**RE: Construction Permit Application for a Proposed Utility Waste Landfill, Ameren Missouri
Labadie Energy Center, Franklin County, Missouri, Response to Comment Letter dated May 7,
2013**

Construction Permit Application
Proposed Utility Waste Landfill
Ameren Missouri Labadie Energy Center
Franklin County Missouri

Response to MDNR-SWMP Review Comments

SHEET 5
PROPOSED UTILITY WASTE LANDFILL
OVERALL BOTTOM GRADING PLAN (TOP
OF LINER)

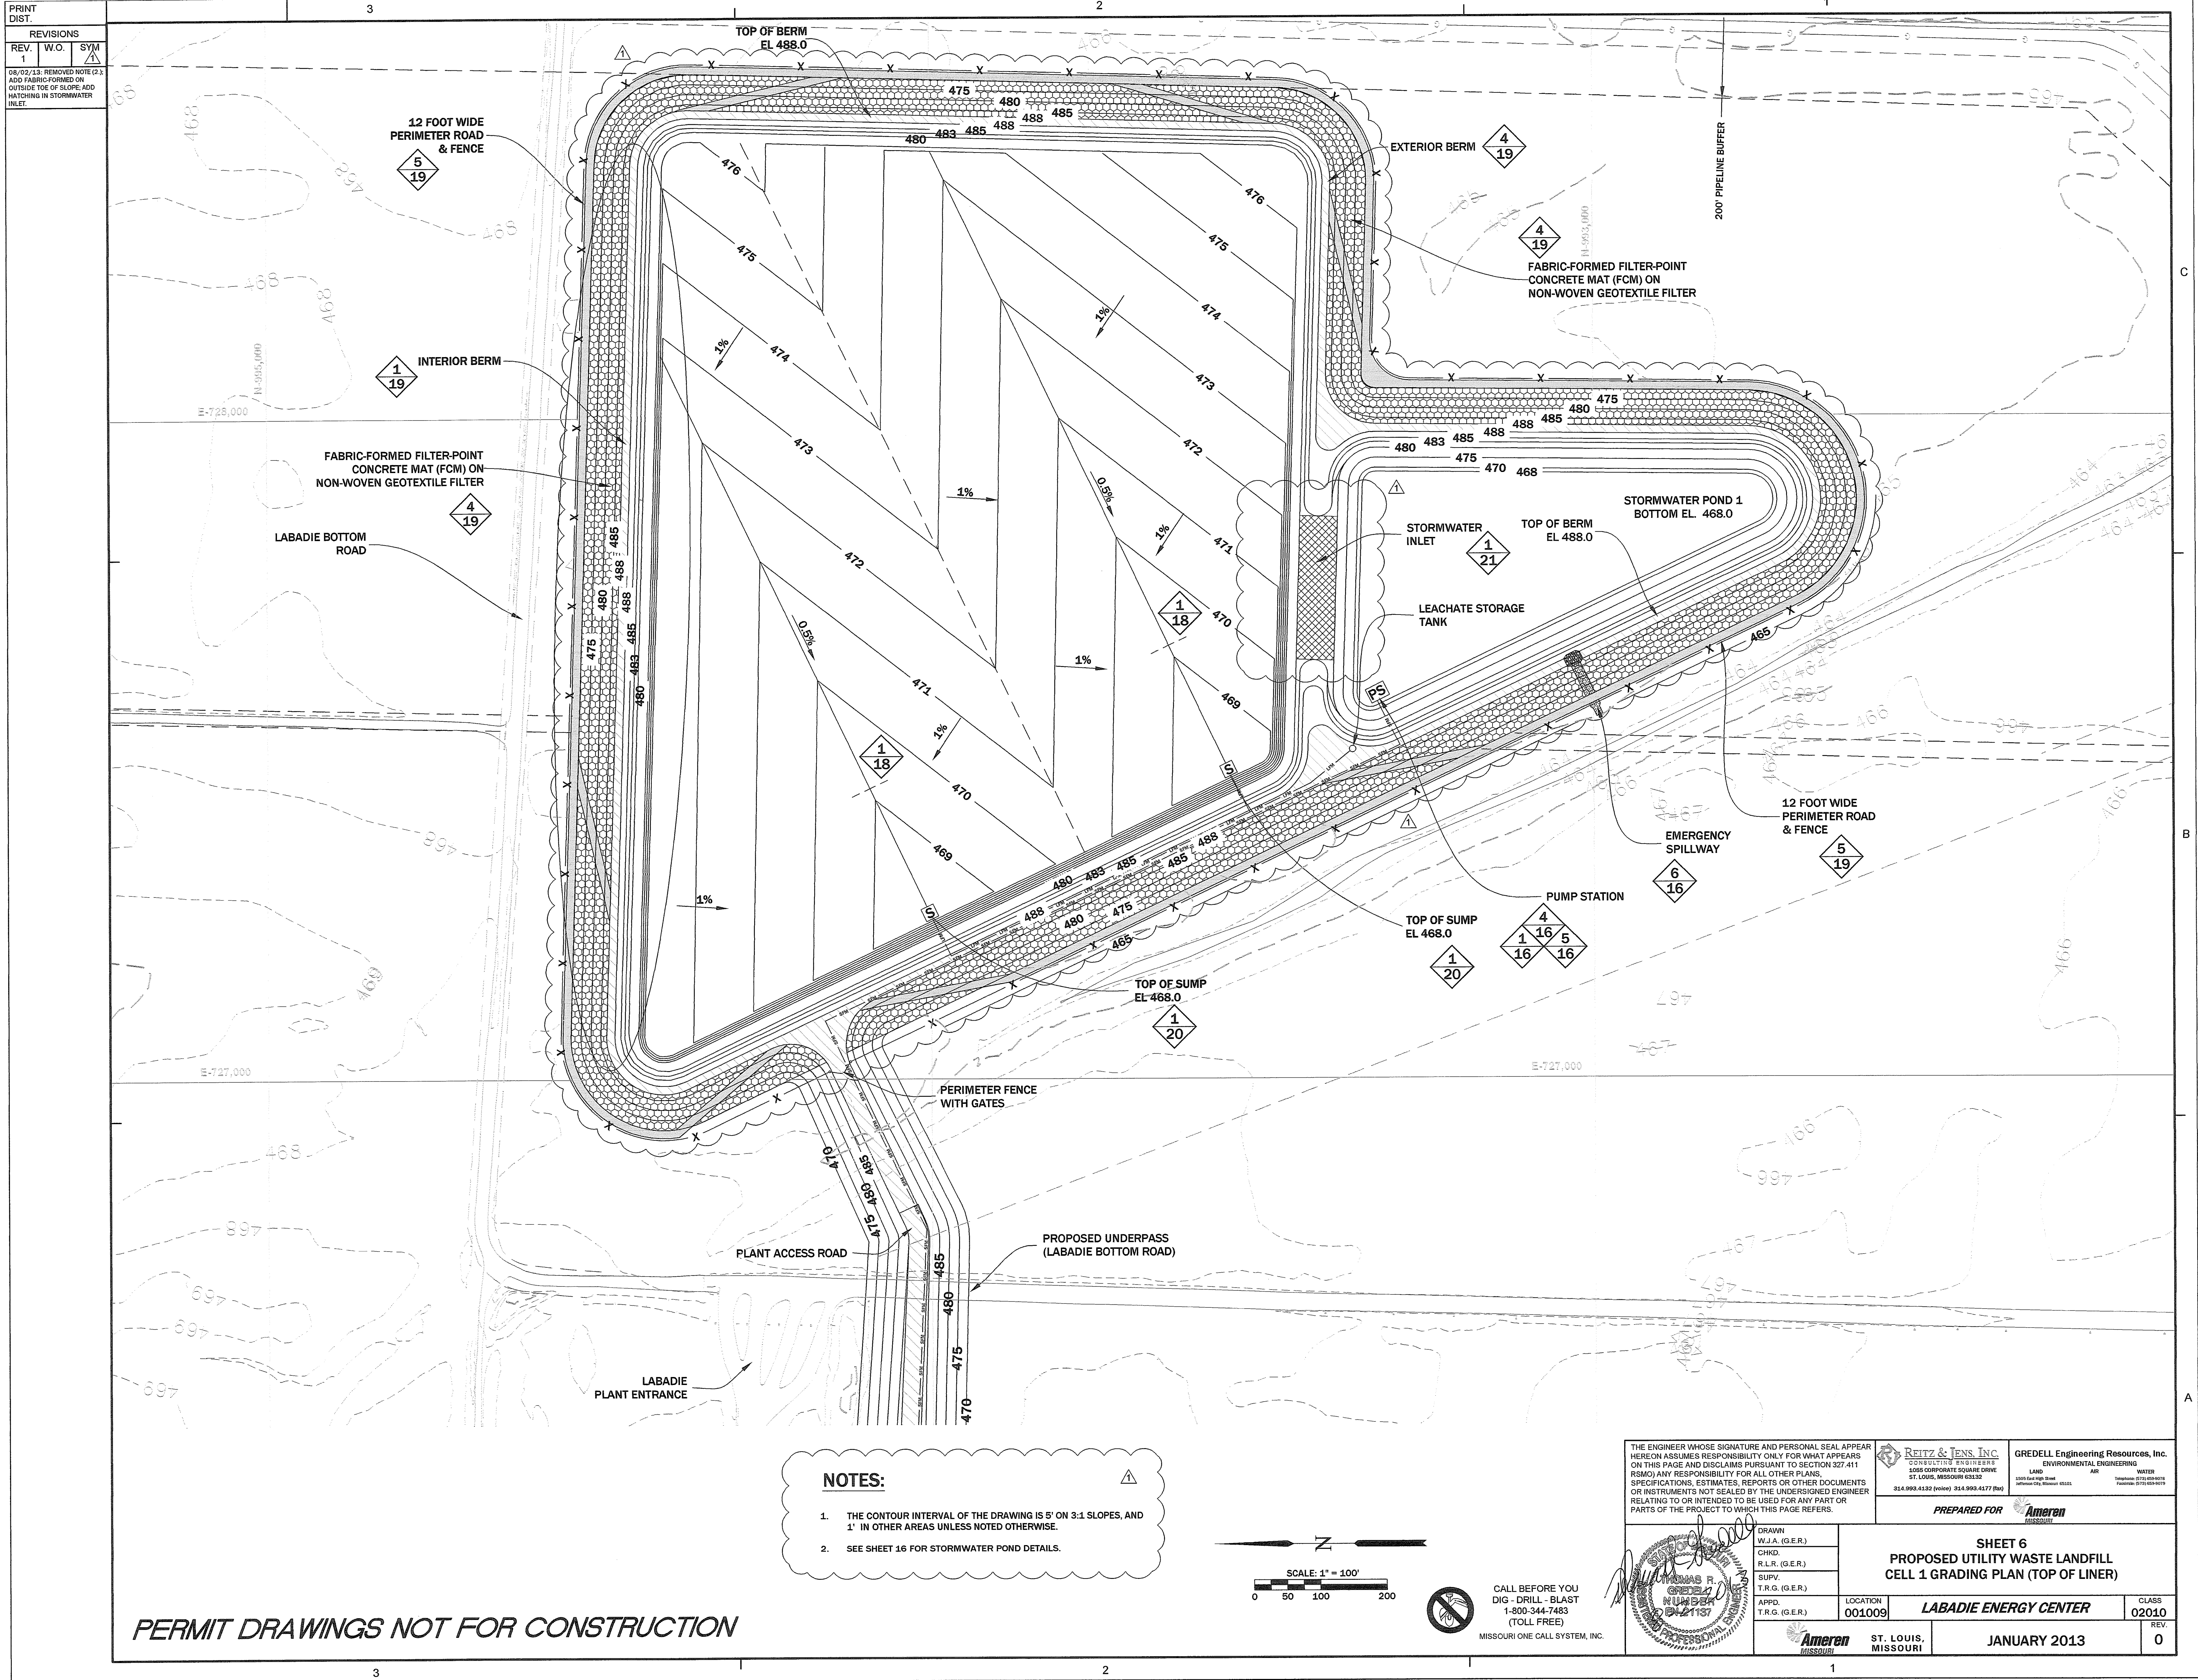
MDNR 9 Please depict the limits of Fabri-Form installation along all berms on all sheets that illustrate the location of the material. **Response:** Sheets 6 through 9 and 11 through 14 have been revised to show the installation of FCM on all exterior berms. Because of the large scale of Sheets 5 and 10 a note was added to each sheet to address this comment.

PRINT	DIST.
REV.	W.O.
1	1
06/02/13 ADD	06/02/13 ADD
FABRIC FORMED TO OUTSIDE	FABRIC FORMED TO OUTSIDE
TOP OF BERM, ADD HATCH TO	TOP OF BERM, ADD HATCH TO
STORMWATER INLET, REMOVE	STORMWATER INLET, REMOVE
NOTE (2.)	NOTE (2.)

SHEET 7
PROPOSED UTILITY WASTE LANDFILL
CELL 2 GRADING PLAN (TOP OF LINER)

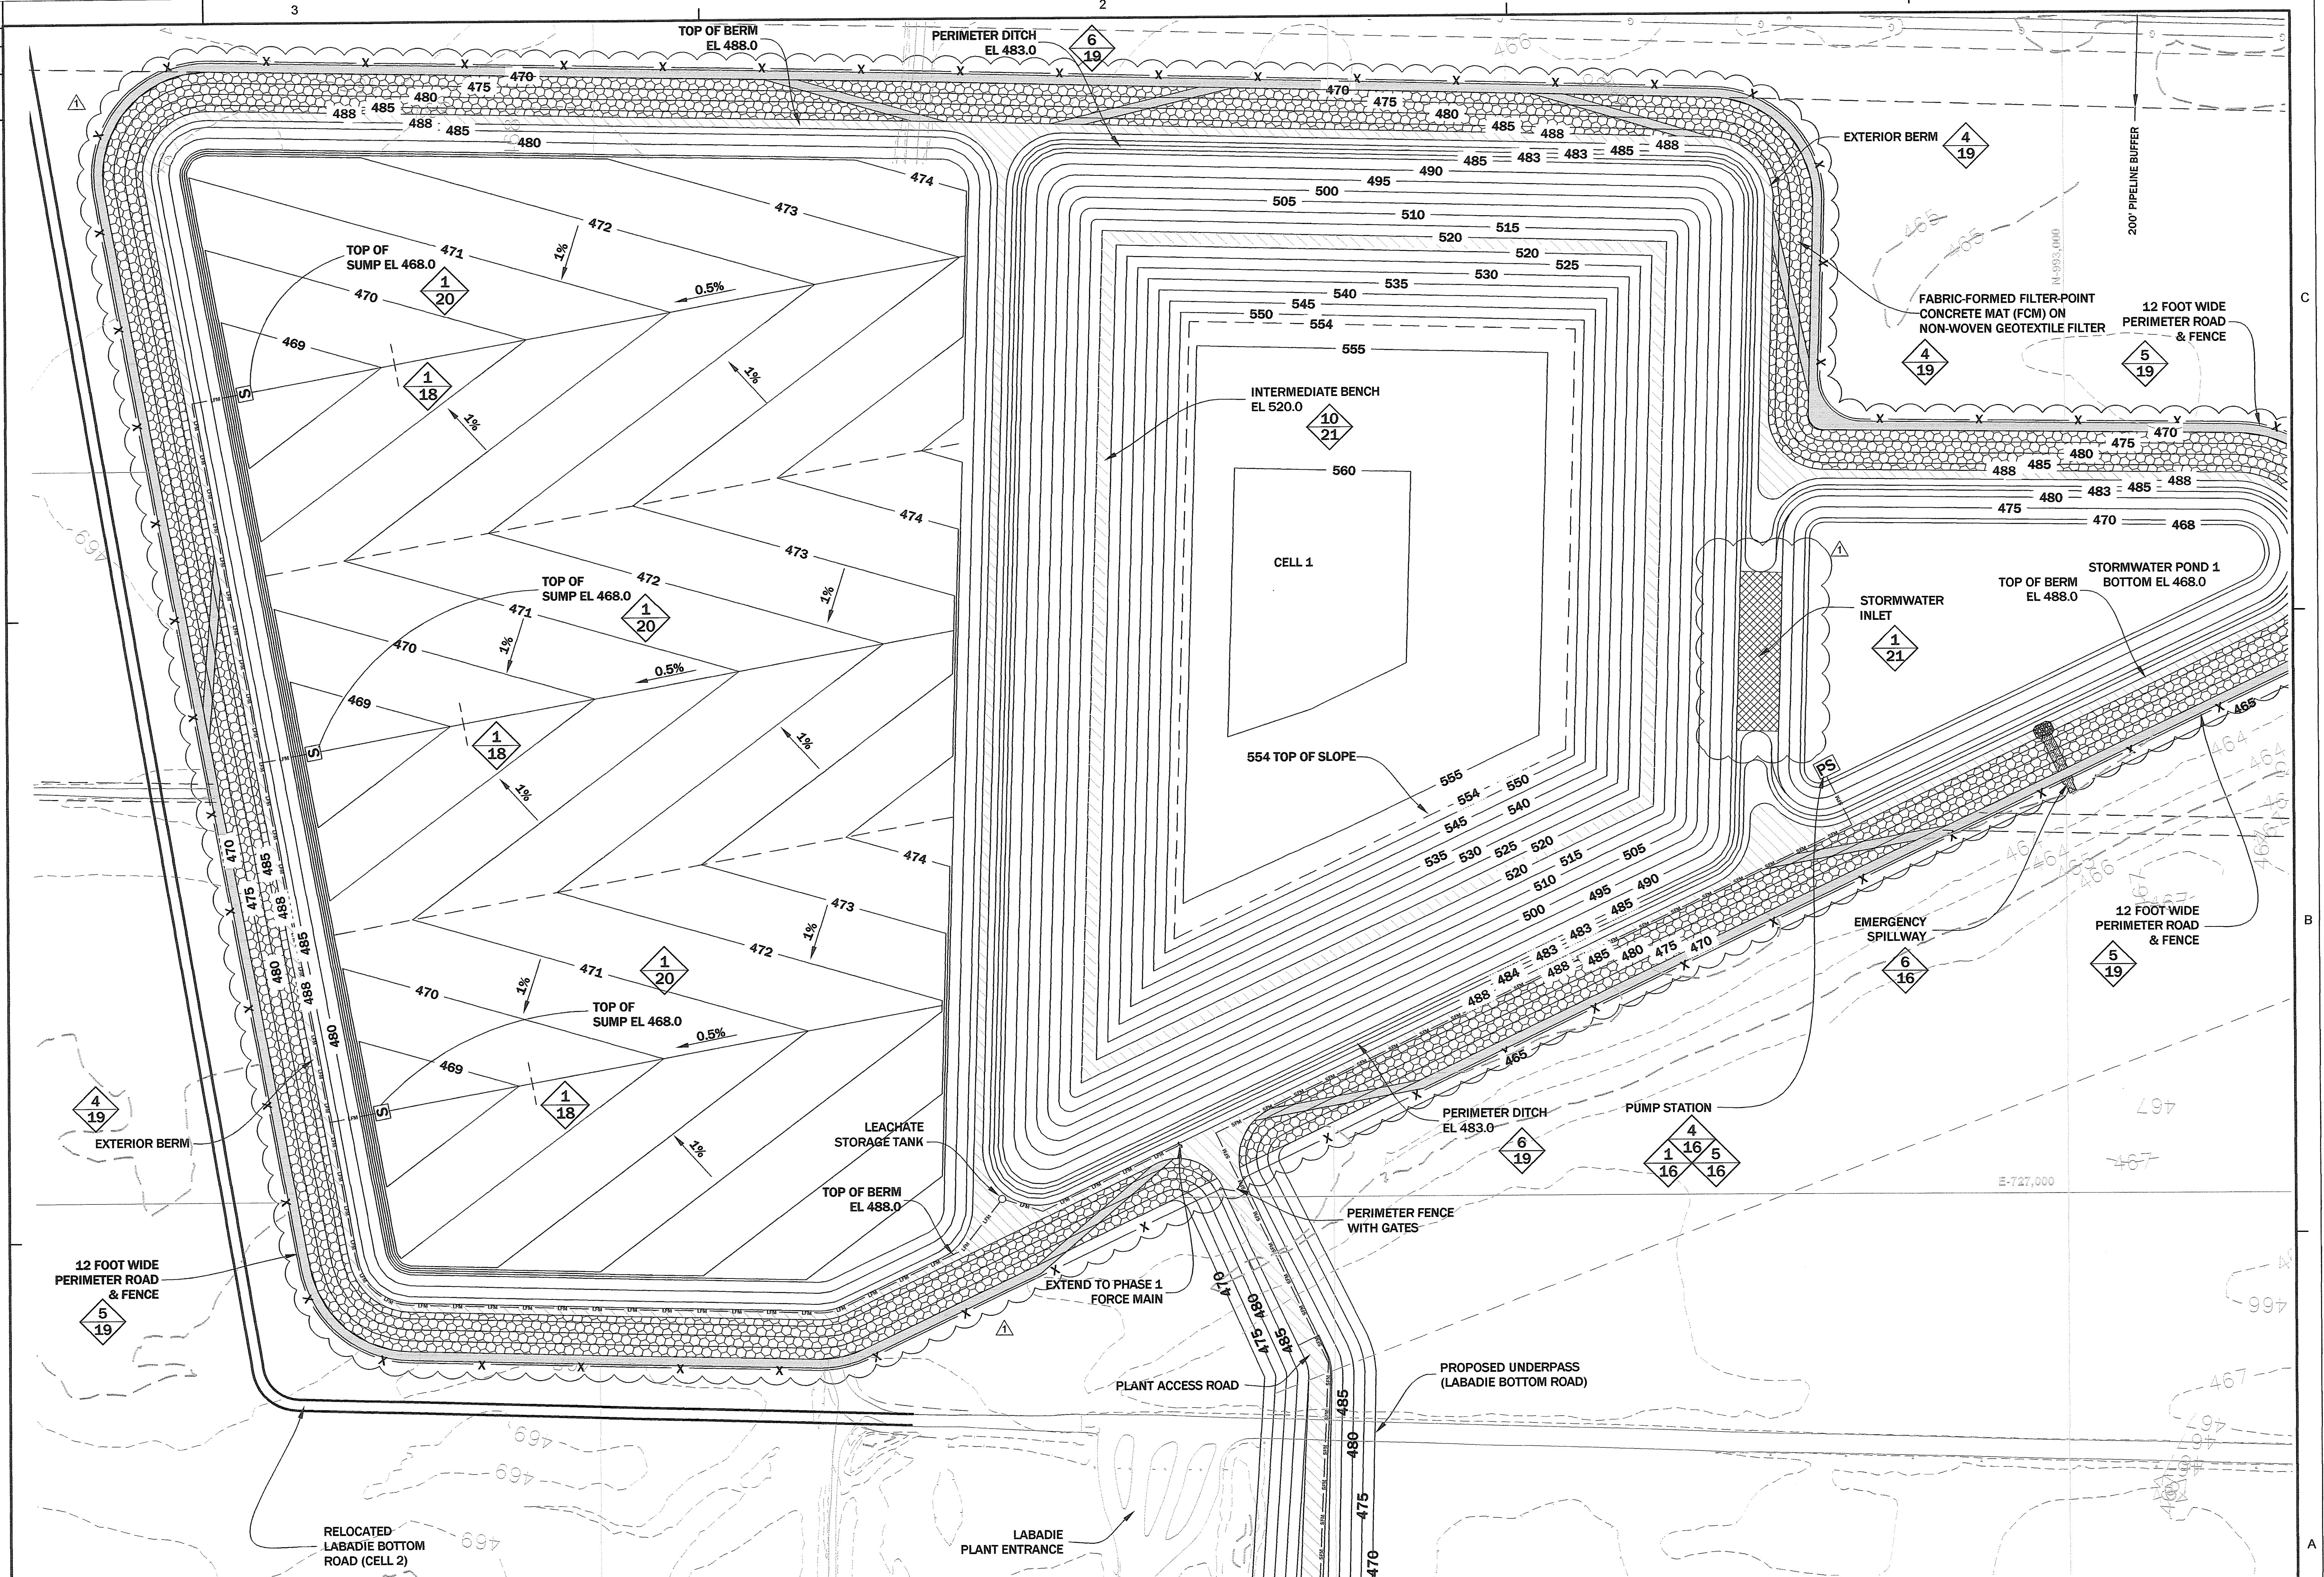
MDNR 8 Remove Note 2 from Sheets 6-9 and 11-14. **Response:** Note 2 has been removed from revised plan Sheets 6 through 9 and 11 through 14, and the notes on each Sheet have been renumbered as appropriate.

MDNR 10 Indicate, through hatching or another method, the stormwater entity along the east berm between the waste cell and basin on Sheet 7. **Response:** Sheets 6 through 9 and 11 through 14 have been revised to identify the stormwater inlets (the stormwater entities) between the appropriate cells and stormwater ponds.

PRINT DIST.		
REVISIONS		
REV.	W.O.	SYM.
1		
08/02/13: ADD FABRIC FORMED TO OUTSIDE TOP OF BERM; ADD HATCH TO STORMWATER INLET; REMOVE NOTE (2).
